**PUBLIC UTILITY COMMISSION OF OREGON  
STAFF REPORT  
SPECIAL PUBLIC MEETING DATE: January 4, 2024**

SUBJECT: PORTLAND GENERAL ELECTRIC:  
(Docket No. UM 2274)  
2023 All-Source Request for Proposals, Request for Partial Waiver of  
Competitive Bidding Rules.

Figure 2: BPA Conditional Firm Transmission Products

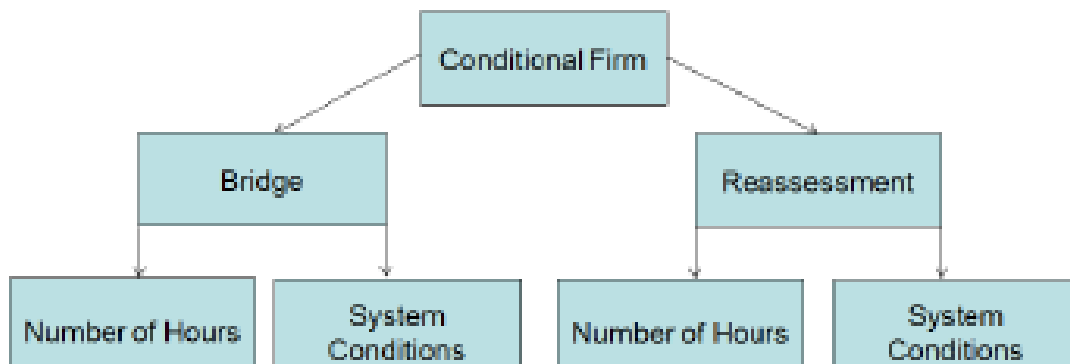
The Final Draft RFP currently considers two of those four products CFB-NH, and CFR-NH, to be conforming. Both CFB-NH and CFR-NH stipulate that transmission rights may be curtailed for a certain number of hours per year with the number of hours specified in the contract at the time it is signed. In general, the hours of potential curtailment are presumed to occur during hours of peak congestion, such as on hot summer days.

in question is Number of Hours or System Conditions.<sup>28</sup> Given that PGE is participating in WRAP, there is substantive justification for considering CF-SC transmission eligible for this procurement. Moreover, while data may be thin on the likely curtailments for CF-SC products, Staff believes this uncertainty can be managed through adjustments to resource ELCCs.

Figure 4: COD Prioritization

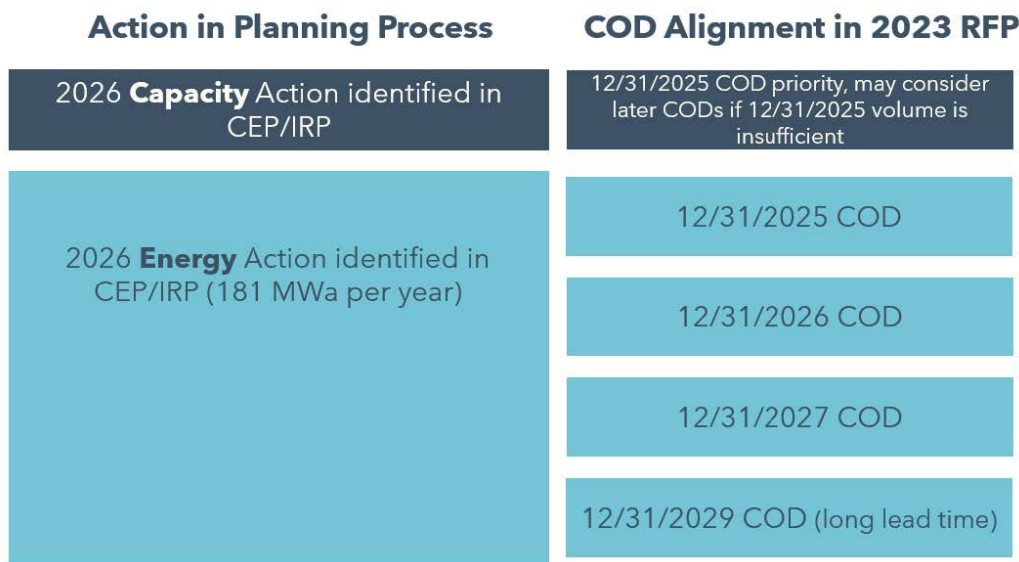
However, the updated approach to CODs as provided in PGE's reply comments raises a new concern. PGE now stipulates that if insufficient resources are available to meet its capacity need by the December 31, 2025 COD, it may consider resources with later CODs to meet that need.<sup>65</sup> At the Commissioner workshop held on July 6, PGE suggested that in that instance, it would prioritize among those projects that cannot meet the preferred COD based on criteria such as capacity contribution or transmission rights.

**RFP Condition 2: Prior to issuance, PGE must provide a description of how it would prioritize resources to fill its capacity needs. PGE must ensure that this**

Figure 5: PGE Affiliate Process Diagram provided in its November 3, 2023 Supplemental Filing

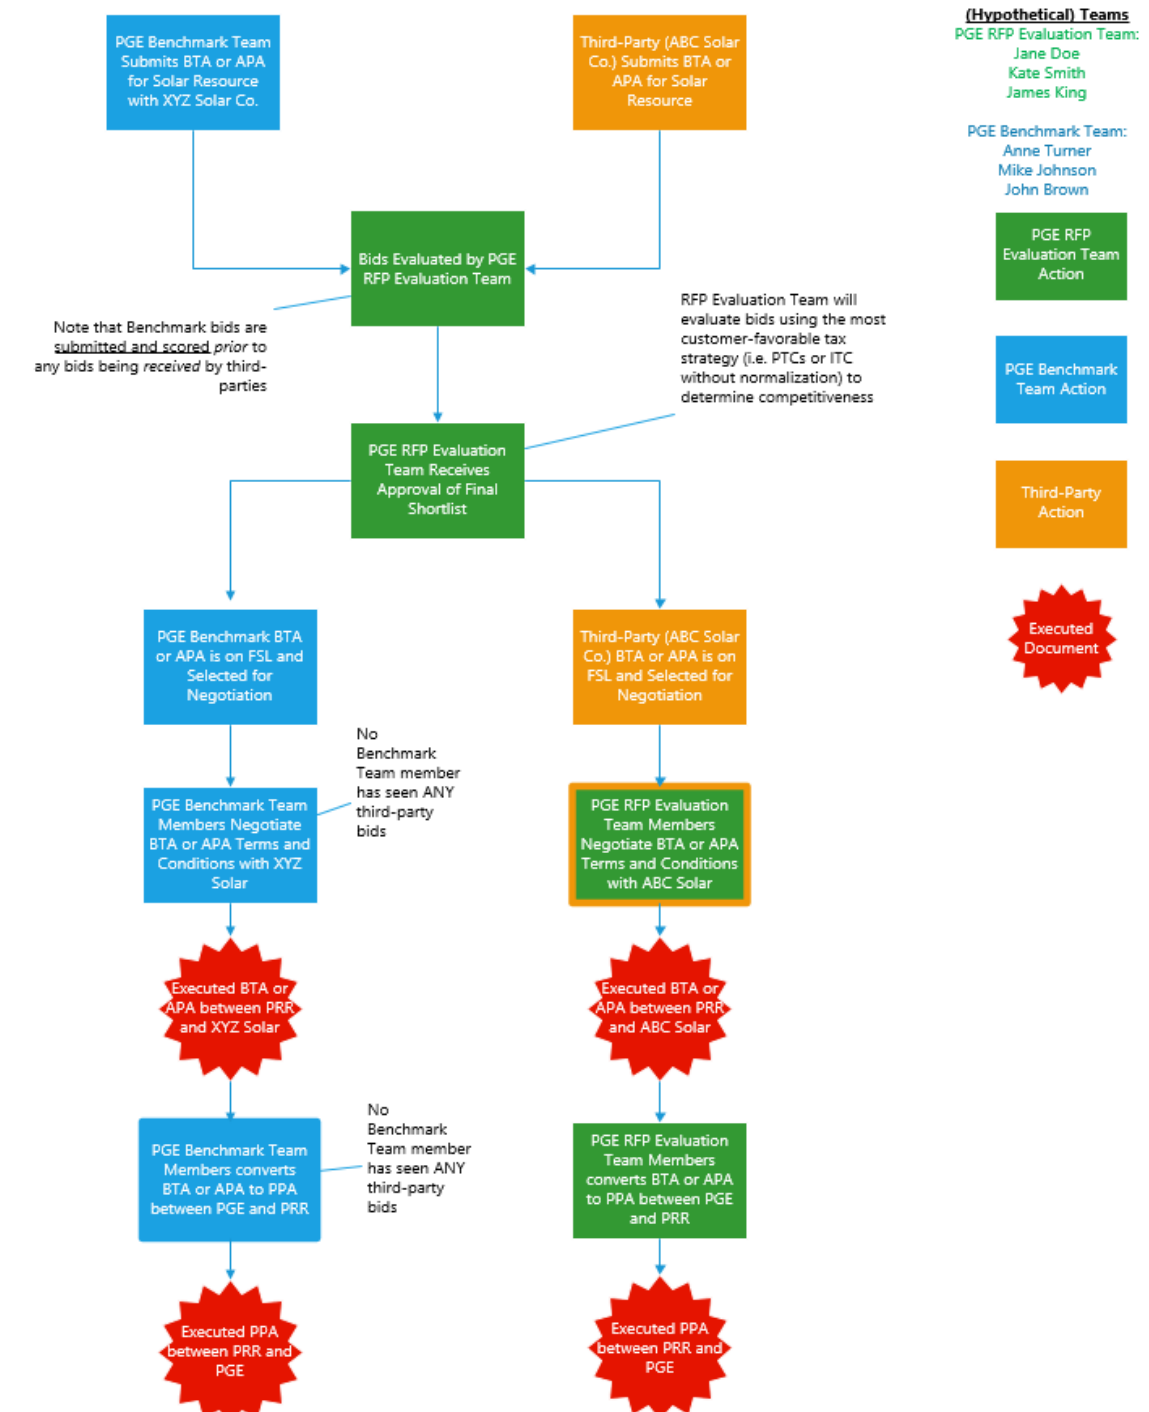
NIPPC, NewSun, and OSSIA submitted comments in response to PGE's Supplemental Filing with concerns and recommendations to address those concerns. All three parties strongly recommended against inclusion of PRR in the 2023 RFP, noting that there has not been sufficient time to assess and mitigate potential harms. NIPPC expressed concern about PGE not seeking approval of the affiliate earlier in the process, the lack of transparency and "minimal to no meaningful" RFP changes to address unique risks from the affiliate participation.<sup>78</sup> Additionally, stakeholders raised concerns about non-conformity with the Competitive Bidding Rules (CBR); PGE/PRR employee access to confidential third-party bidder information in this and future RFPs; and NewSun and OSSIA further noted that the inclusion of PRR exacerbates existing unfair practices favoring utility bids. These issues are addressed in the section below, Overarching Concerns.

Figure 6: PGE PRR Parallel Contract Development

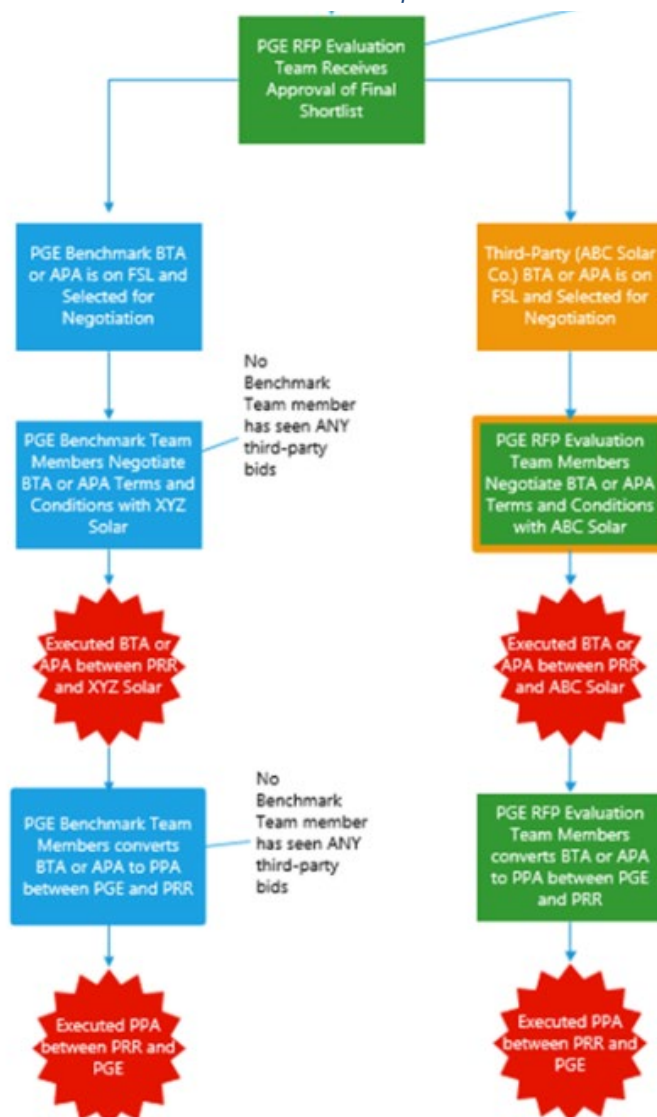
Figure 6 show an excerpt from PGE’s November 3 Supplemental Filing, showing the how the describes two parallel paths for arriving at the executed PPA agreement with PRR, depending upon whether the bid is submitted by a PGE-sponsored benchmark (Benchmark ITC-e) or a third-party non-benchmark bid (Third-party ITC-e).<sup>86</sup>

The Company further explains that the conversion of the BTA / APA to a PPA would be done using “standard economic practices” and then updating exhibits and project specific information in the Form PPA referenced in the RFP. The executed BTA/APA forms the basis of the PPA price. This price would be captured, along with project details, in the PRR Form PPA and becomes the critical elements of the contract between PRR and PGE. PGE explained that it is through the BTA/APA contract negotiation process that details about project costs can be solidified and then accurately converted into the PPA price.

Figure 7: PRR Contract Negotiation Parties

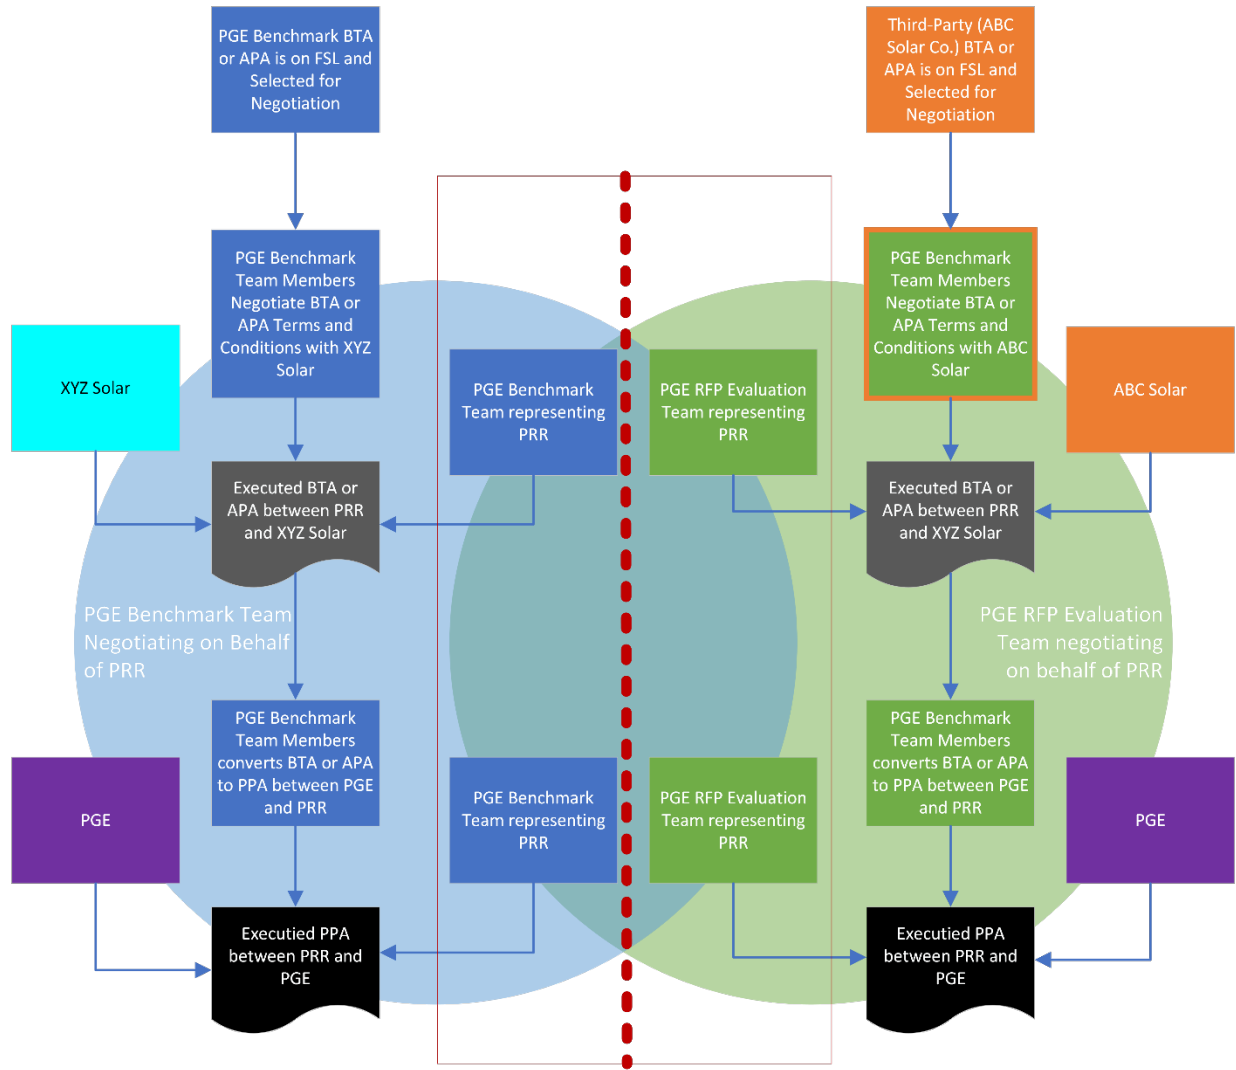
PGE explains that PRR will not have staff but will ultimately leverage PGE staff both to negotiate PPAs and after PPAs have been signed. Regarding negotiations, PGE appears to represent, in figure X, that the PGE Benchmark team would represent PRR in the BTA/APA contract negotiation with a third-party project developer/owner of the Benchmark ITC-e project. Alternatively, the PGE RFP Evaluation team would represent PRR in BTA/APA contract negotiations with a third-party project developer/owner of a Third-party ITC-e project. The outcome of these negotiations is an executed BTA/APA between PRR and the project developer.

Staff sees a similar lack of clarity regarding the role of negotiating parties and has concerns about how the required separations would be executed, maintained, and demonstrated. Staff notes that even if the PGE RFP Evaluation team is responsible for converting the BTA/APAs into PPA prices, it is unclear which PGE employees would be representing PRR, and it appears that it would be a combination of both Benchmark and RFP teams, threatening the requirements for separation. As shown in Figure 7, Staff's primary concern is regarding knowing who specifically on the PGE Benchmark and RFP teams will be engaged in the negotiations captured in the red box and how the Company will demonstrate that it maintains the necessary separations, as indicated by the dotted line. This concern becomes more acute after contracts are executed and need to be enforced.

Regarding negotiations, Staff provides recommendations in the section on PRR Form PPA regarding documentation. Staff addresses this issue further in the Section on Post PPA Execution.
